Access Compliance Report

Public Rights-of-Way

(Curb Ramps)

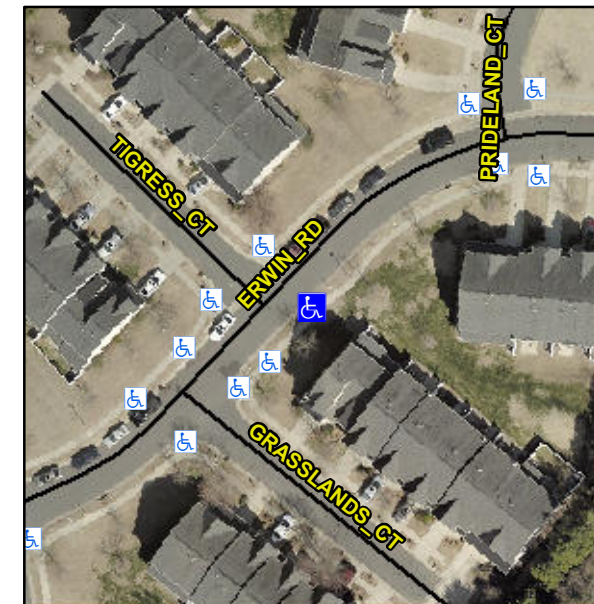
Intersection ID: 48865	Main Street: TIGRESS_CT	Cross Street: ERWIN_RD	Location: SE
ADA ID: 96D370AC5042	Ramp Type: Perp	Initial Pass/Fail: Fail	Overall Compliance: No
Codes/Mitigation Info/Possible Solution		Field Measurements/Component Compliance	
Severity Score: 12.5

Not Found, R304.2.2

Remove & Replace Entire Ramp.
